### ***Map Correction-Field Verification***

**Drain Name:** Vernon Asher Drain

## VERNON ASHER DRAIN STA 39+60 TO 42+45 (TERMINUS)

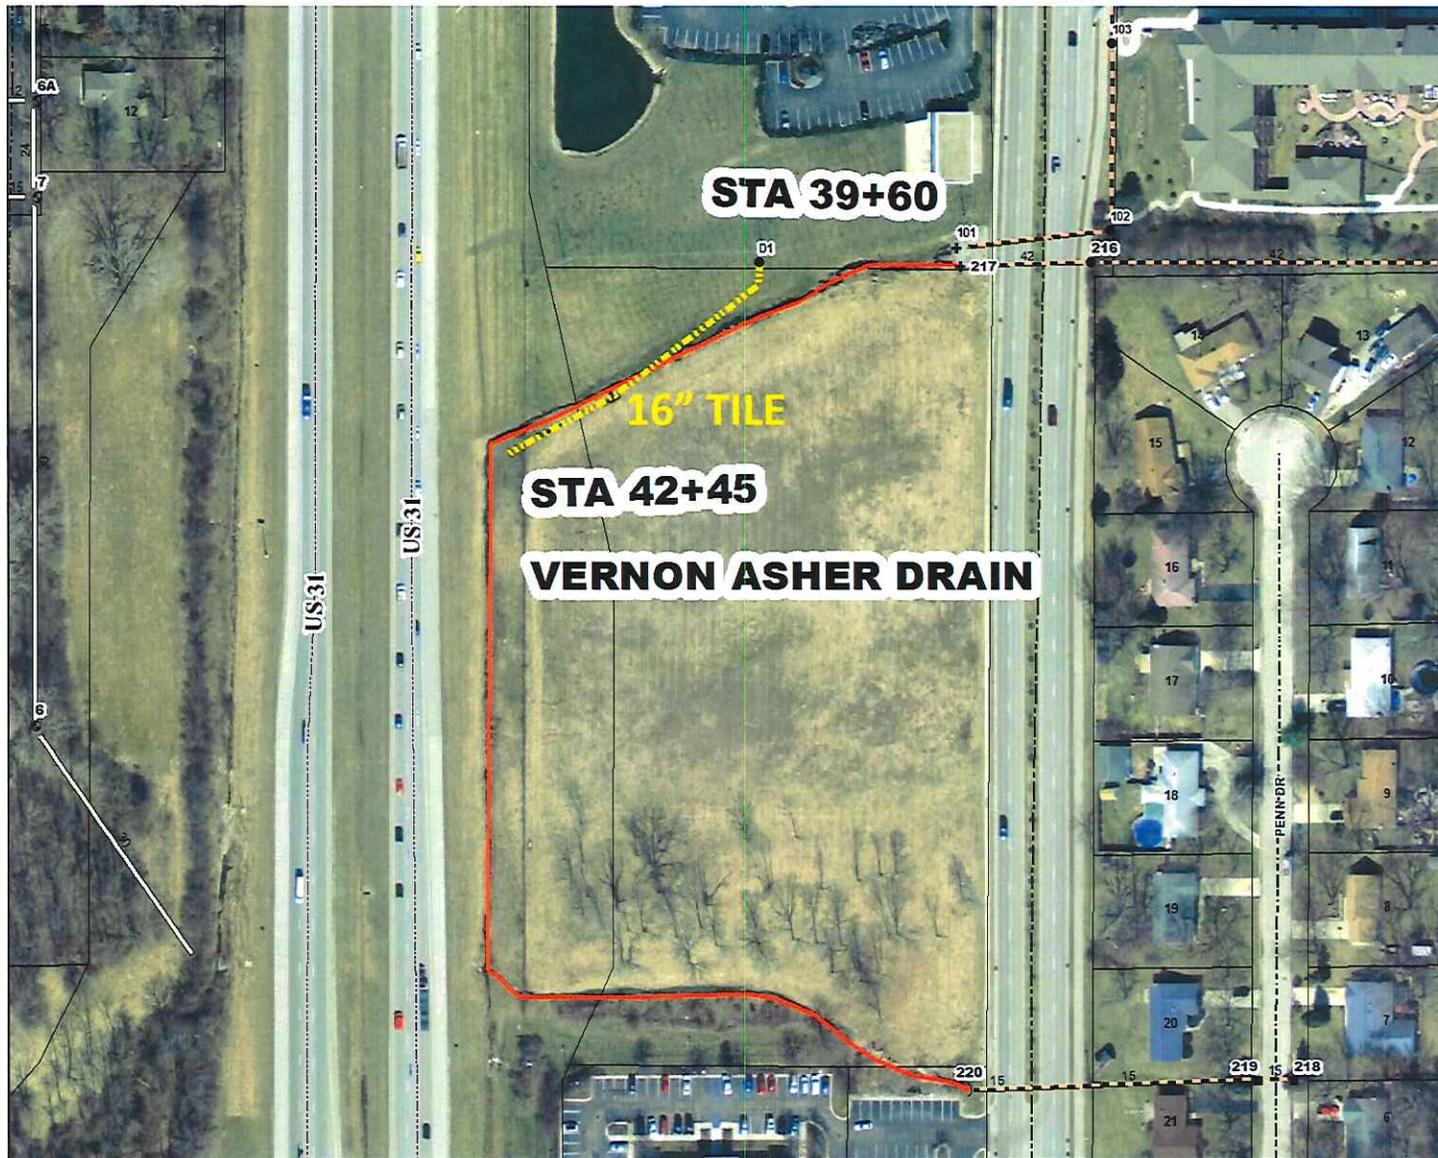
It was recently discovered that the Vernon Asher tile was not vacated from Station 39+60 to Station 42+45 (terminus). The 16" tile between these stations was installed in 1939. The tile was field located from the Manhole set on the tile with the Delta Faucet site to the east right of way line of US 31 as it existed in 1939. The tile had two visible blow holes on the tile just east of where the swale turns south.

**Change + / - :** 285

**New Length:** 2250
